REVIEW OF WATERFORD III BASEMAT ANALYSIS

Structural Analysis Division
Department of Nuclear Energy
Brookhaven National Laboratory
Upton, NY 11973

June 21, 1984

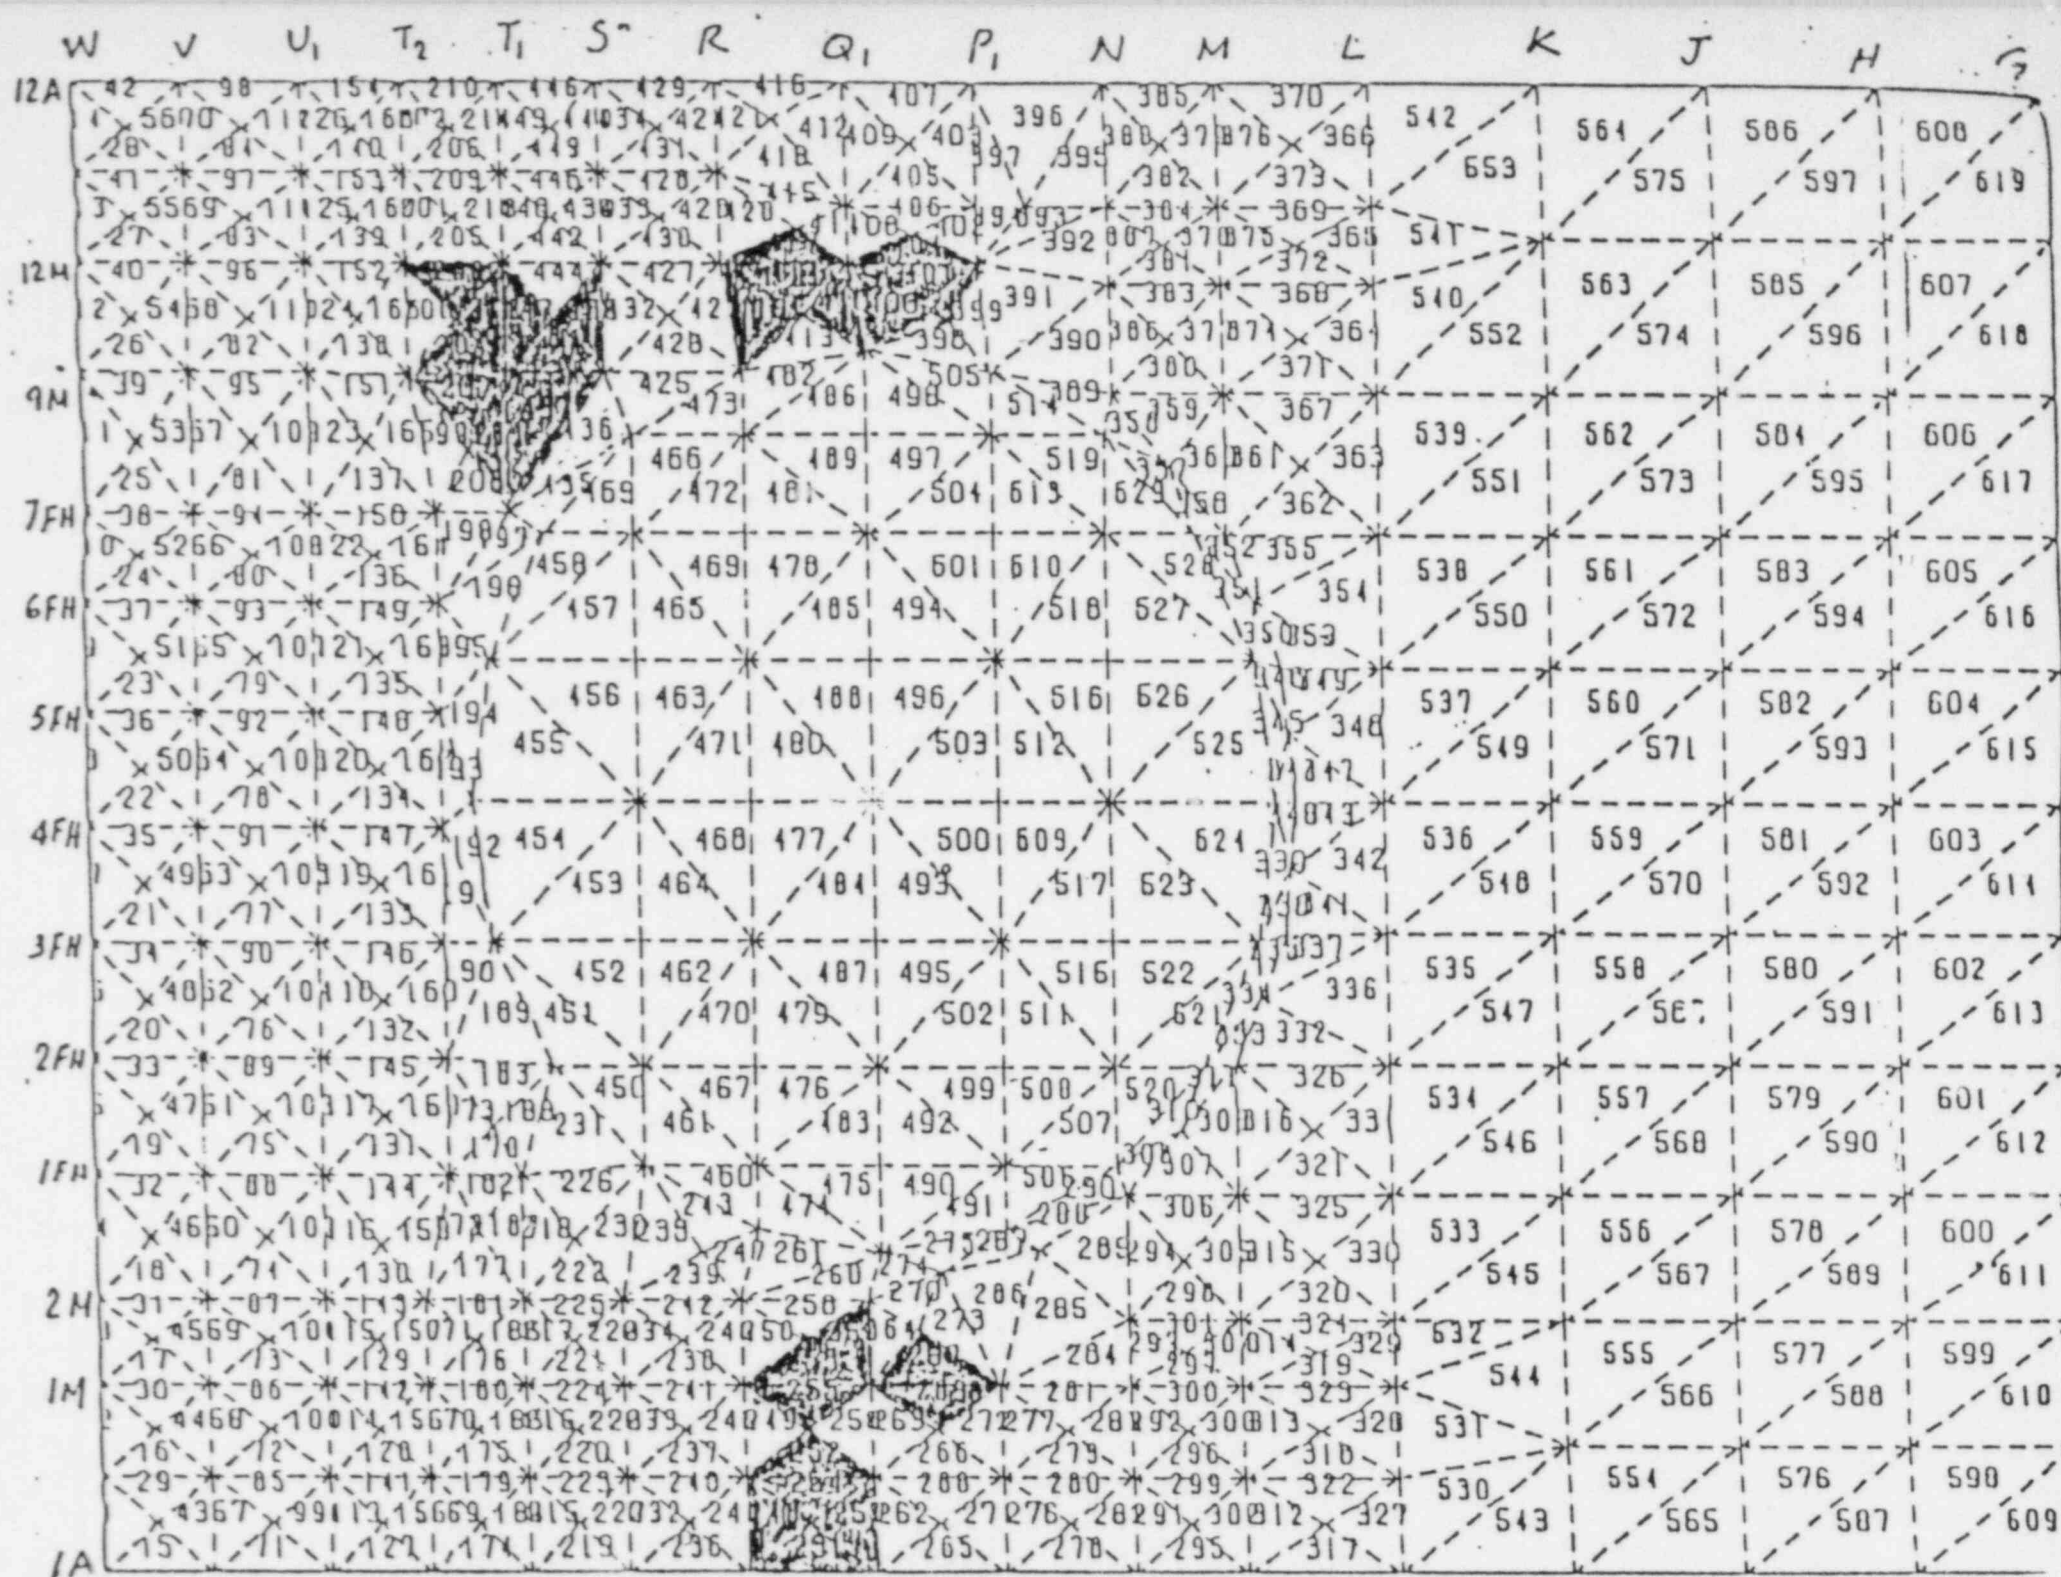
As mentioned, EBASCO in their discussion and HEA in their reports have not shown analytically, the cause of the top surface cracks. In reviewing the HEA computer outputs, it was found that element moments and shears for individual loadings are explicitly given. Thus, for the case involving dead loads only, a number of elements in the cracked regions exhibit moments (positive in sign) that can produce tension and thus create cracking on the top surface. This situation is shown in Table 1 which gives moment data (M_x , M_y and M_{xy}) for elements under various load conditions (dead (D), buoyancy (B) and normal side pressure) in some of the cracked regions. The particular elements are also depicted by the shaded areas shown in Fig. 1.

In checking the data shown in Table 1, it is to be noted for example, that for element 208, the dead load (D) moments M_x and M_y are respectively equal to 350 and 895 ft-kips/ft and are positive. Thus as mentioned previously, the top surface is in tension. The maximum principle moment is a function of M_x , M_y , and M_{xy} and its computed value is close to 1000 kip-ft/ft. This moment exceeds the working stress capacity and thus cracking will occur. Similarly, concrete cracking could occur under the dead load condition in elements 447, 212, 204, 253, 255, 269, 257, 417, and 404. Thus, the cracks on the upper surface outside of the shield wall could have been initiated after construction of the superstructure, before placement of the backfill.

Thus, in summary, the cracking is most probably caused either by dead loads alone or by dead loads acting on elements somewhat weakened due to previous thermal and shrinkage effects. Essentially, for the latter case, the dead load moments would enhance previously existing small and most likely non observable cracks causing them to become larger and hence, observable.

The additional east-west direction top reinforcements will also cause prevailing cracks in elements located directly east and west outside of the shield wall circle (i.e., those shown shaded in Fig. 1 in areas R-P-2M-1A and R-P1-12A-9M) to be oriented in an east west direction. This is indeed the pattern indicated in Fig. 3. Since there is no additional top reinforcement in the elements shown shaded in Fig. 1 located between sections T2-R-12-7FH, the prevailing cracks do not necessarily have to be oriented in the east-west direction.

Fig. 3 CRACK MAPPING PER
RR/GW 9-21-83 to 9-2-83
for HEA, IOL (A+B)

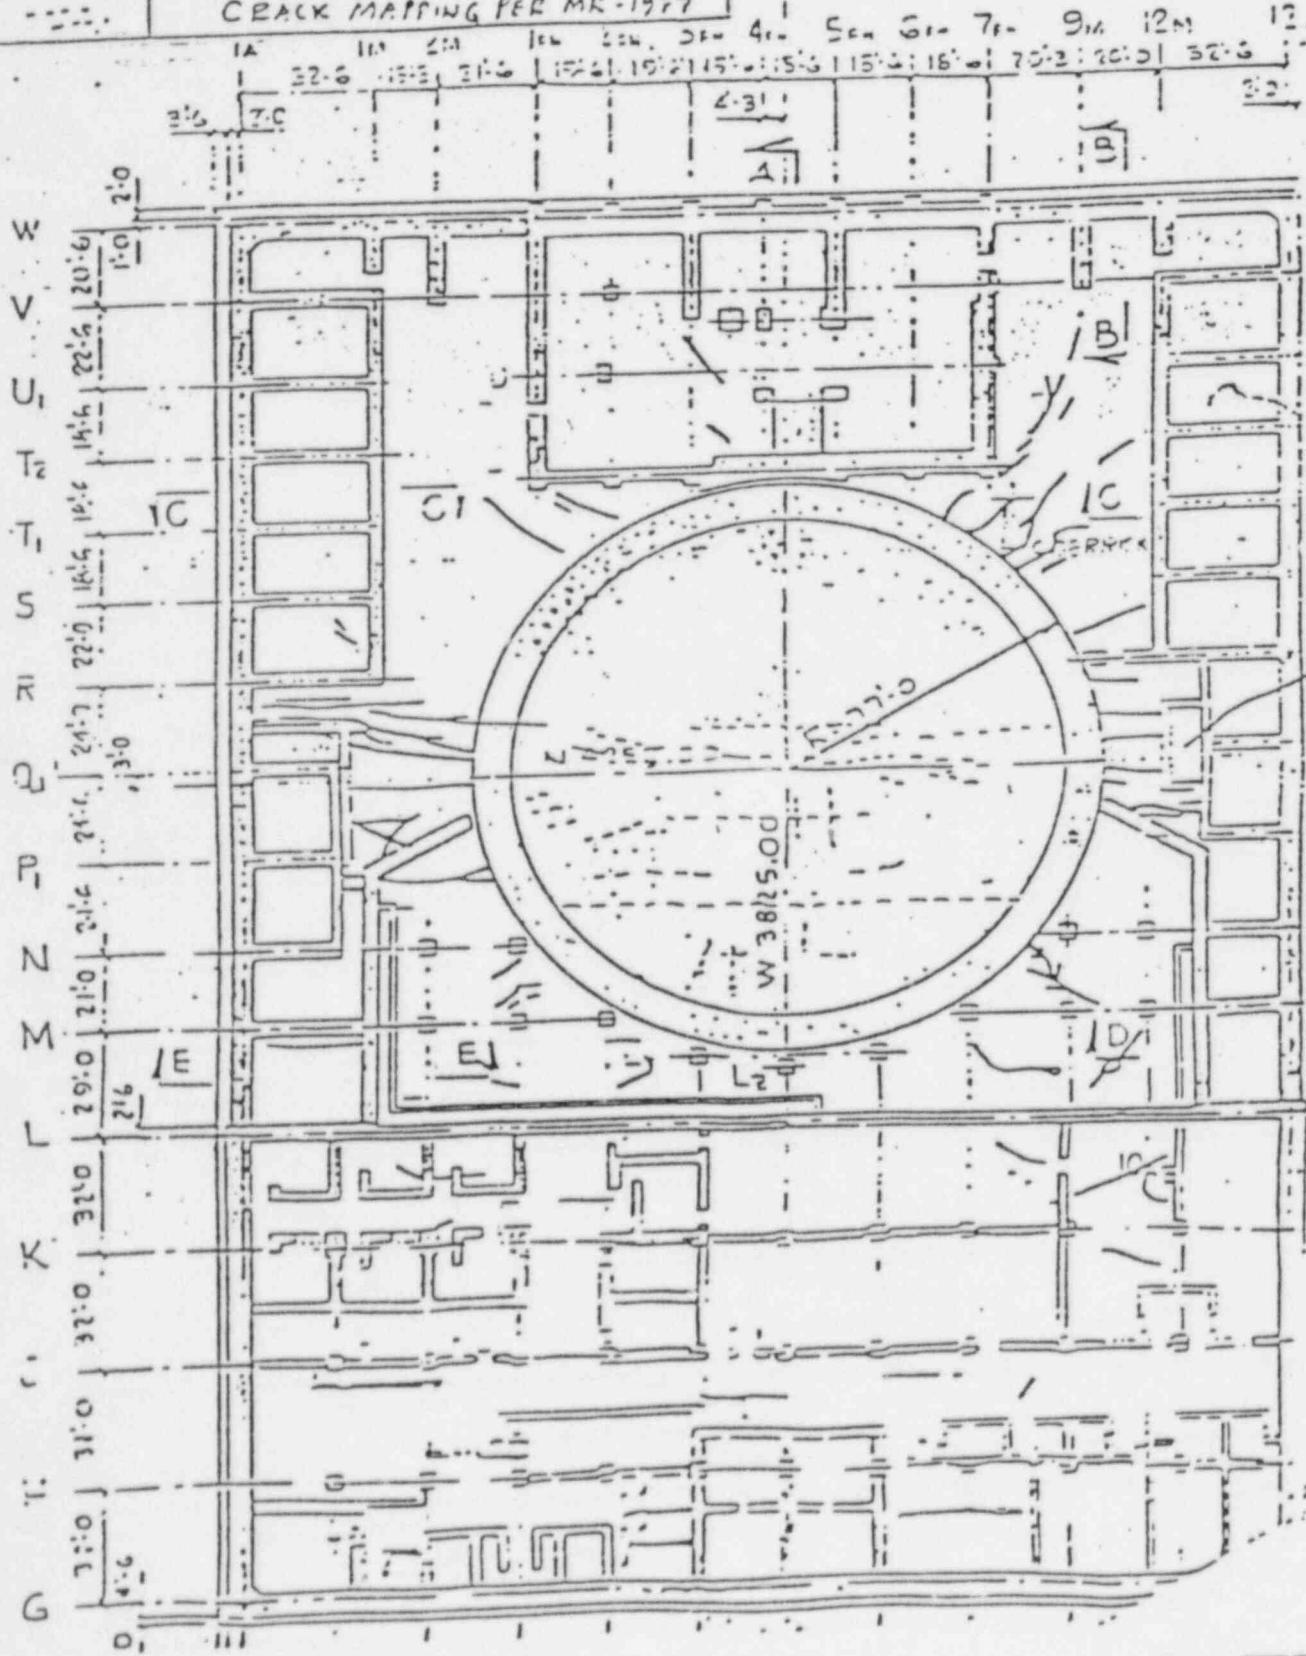
As shown in Table 1 and in Fig. 1, the discussion thus far only pertains to cracks outside of the shield wall. As shown in Fig. 3 crack patterns were also noted in March of 1977, internal to the shield wall. At that time the shield wall was partially constructed up to elevation 187' and the steel containment was supported on temporary footings. Other walls or structures on the mat were either not as yet constructed or were only partially constructed. Since the computer dead load calculations refer to the mat with all existing structures, it is not possible to utilize the computer results to explain the 1977 cracks. It should be pointed out however, that the additional top reinforcements (i.e., # 11 @ 12" shown in Fig. 2) are essentially located in areas under the shield wall and are placed in an east-west direction. Thus, if cracking should occur the preferred direction would

be parallel to the direction of the heavier reinforcement. This is indeed the direction of the cracks. They could be due to curvature during construction and dead loads acting in conjunction with thermal and shrinkage effects.

FIG 4 BOUNDARY CONSTRAINTS

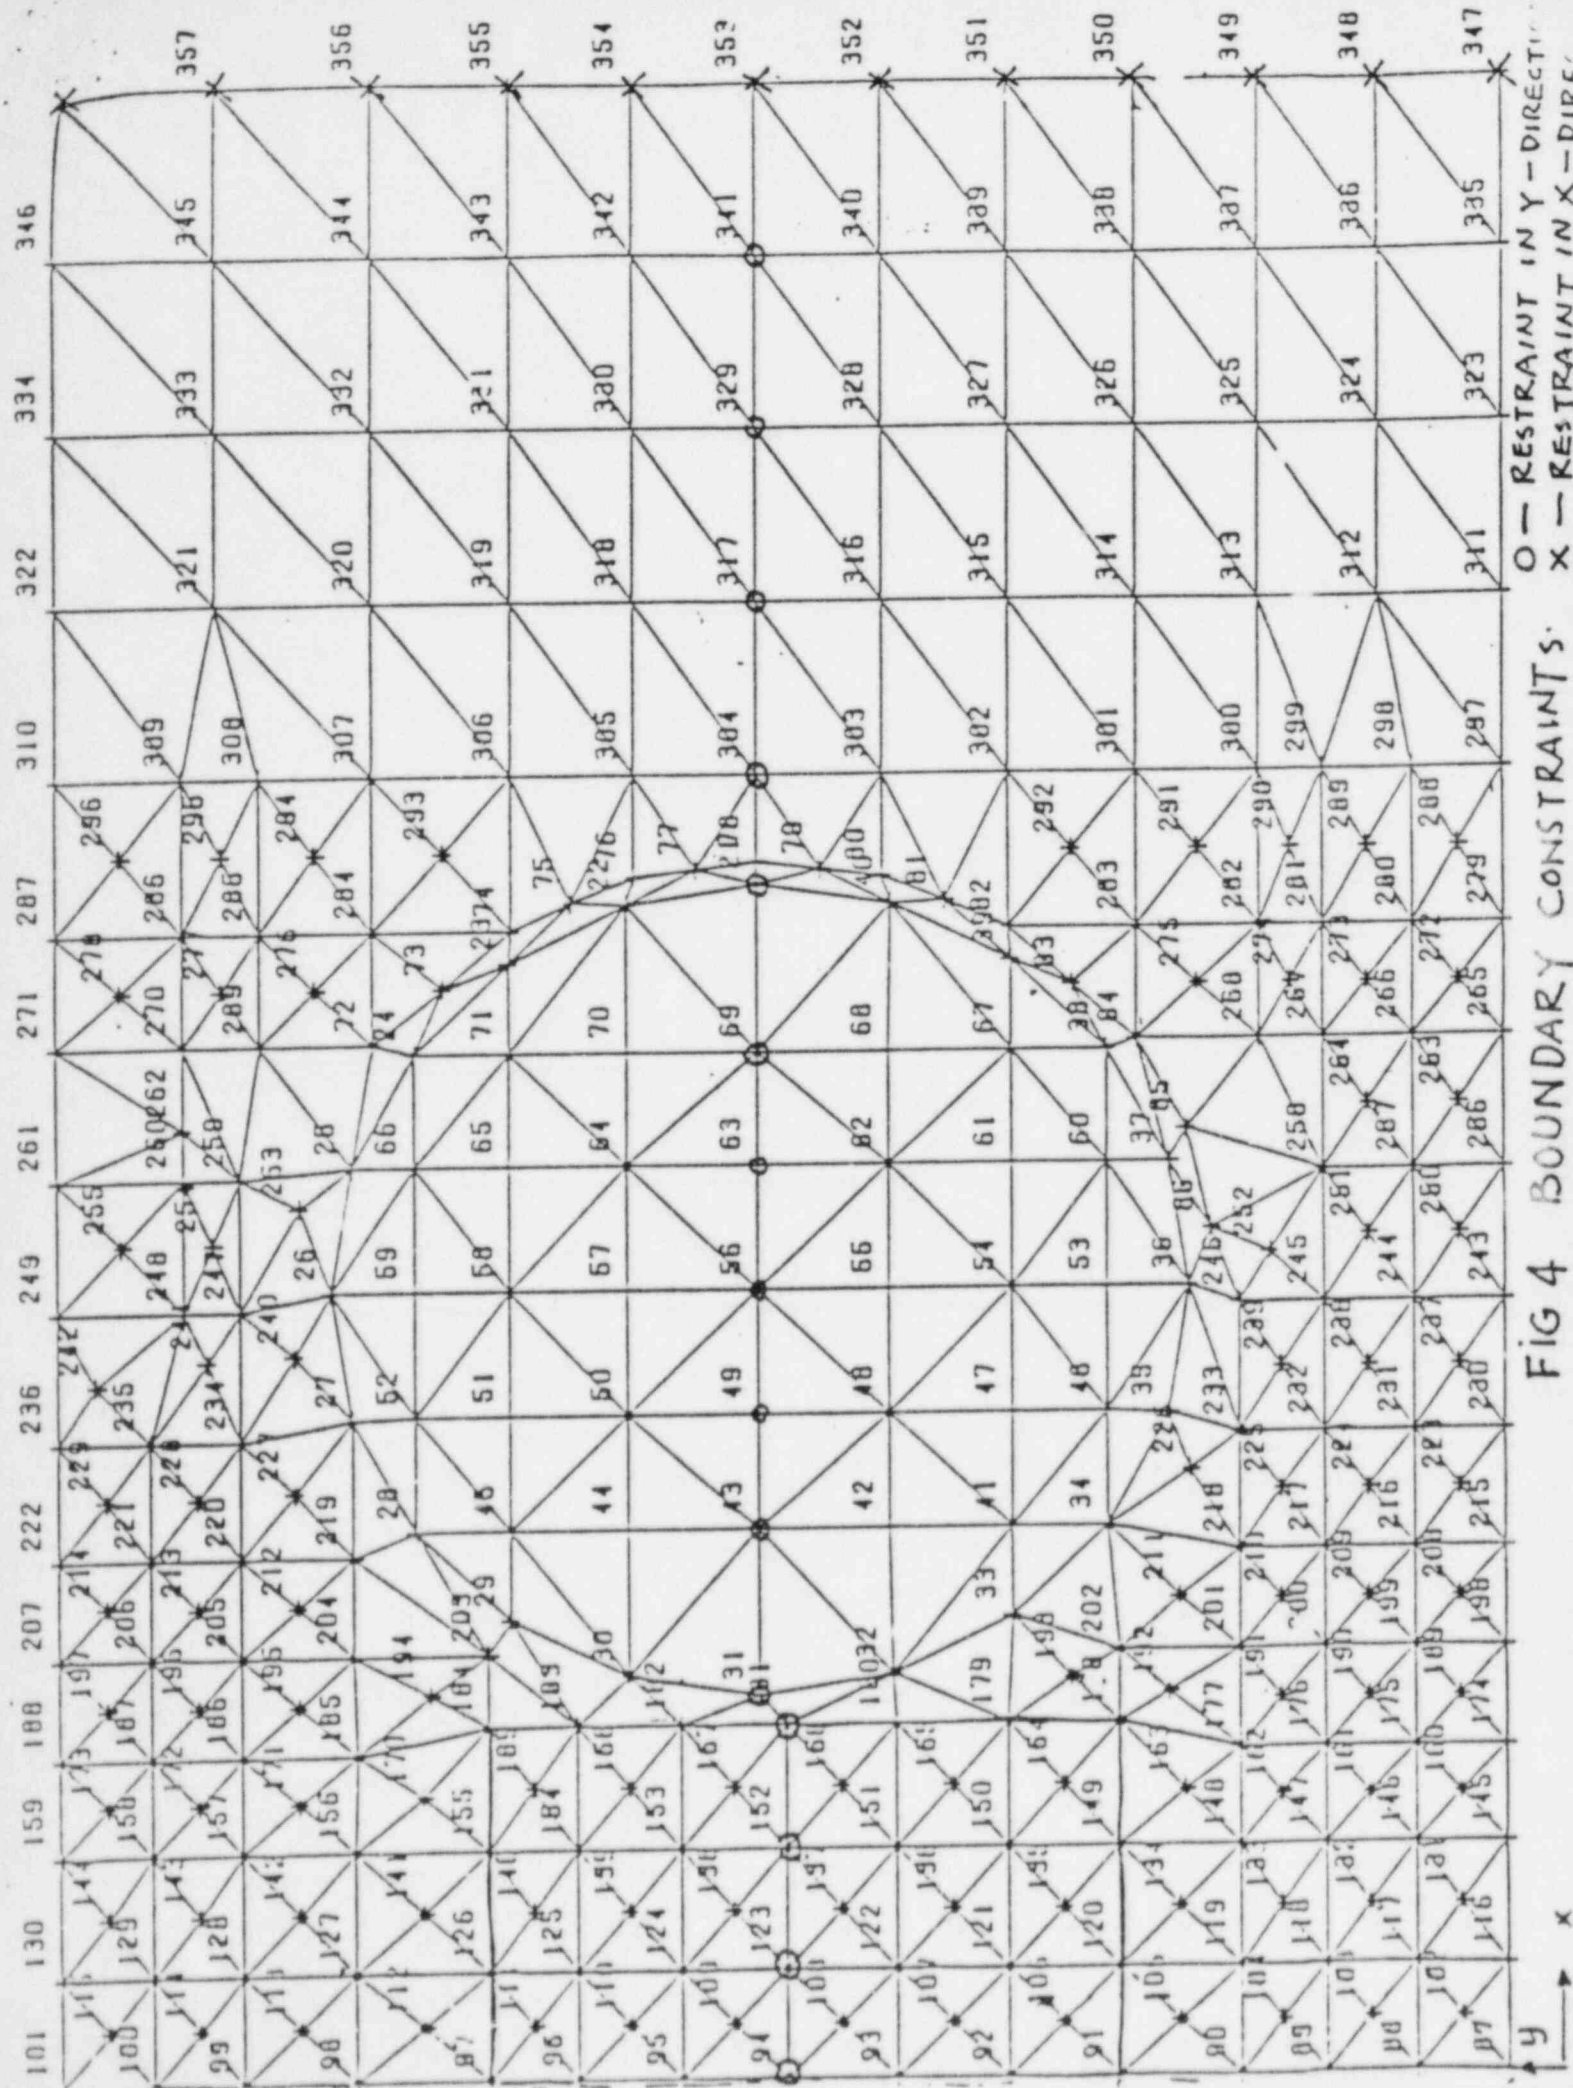
For equilibrium calculations no special consideration need be made for vertical case since the soil springs prevent unbounded structural motion. However, the same cannot be said for the horizontal case since soil springs are not used to represent the soil reactions. Rather the lateral soil forces are directly input to the model. To prevent unbounded rigid body motion, artificial lateral constraints must be imposed on the model. The constraints are depicted in Fig. 4. The nodes shown circled were constrained from movement in the y direction, while those described by "x" were constrained in the x direction. As commonly practical in finite element applications, the constraints are placed in a manner that they do not overly affect the static and dynamic response calculations. From the output presented in the EBASCO and HEA reports, it is not possible to evaluate the impact of the above shown boundary assumptions. The stresses caused by the artificial boundaries should be calculated and compared with those presented.

Fig. 1 Construction of Two Adjacent Blocks

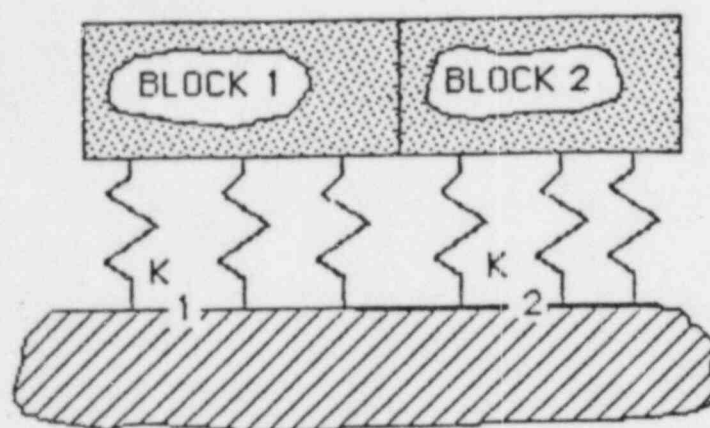
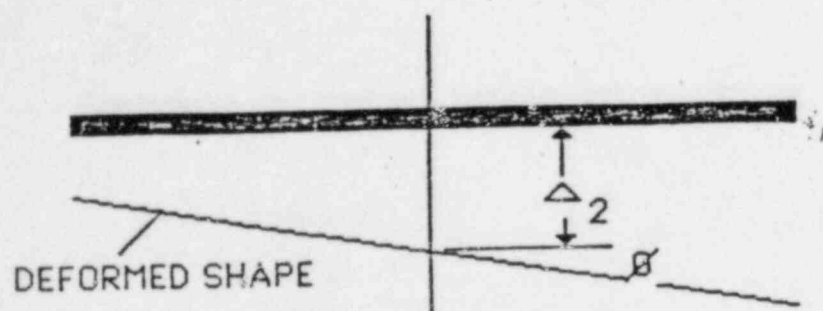
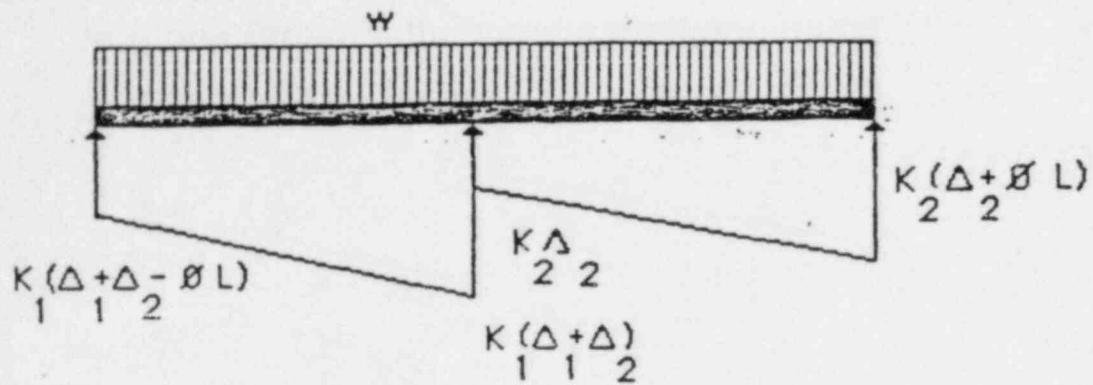
A question has been raised concerning the stresses which could have been introduced when the basemat blocks were being poured. The response of two adjacent blocks during construction are considered. The first block is taken to be in place when the second block is placed. It is also assumed that the concrete in the second block hardens immediately so that it can transmit loads to the first block. The subgrade modulus under the two blocks is assumed to be different so that the effect of soft spots in the soil can be considered. A sketch of the problem to be considered is shown in Fig. 1.

The second block is then poured. If the concrete is conservatively assumed to harden before the soil settlement can occur, the second block will introduce additional loadings on the first block. The new deformation caused by the weight of the second block is shown on Fig. 2.

The loads acting on the block may then be determined by multiplying the deformations by the foundation moduli. These loads are shown on Fig. 3. Force and moment equilibrium allow the two unknown displacements (Δ_2) to be calculated. The results are,
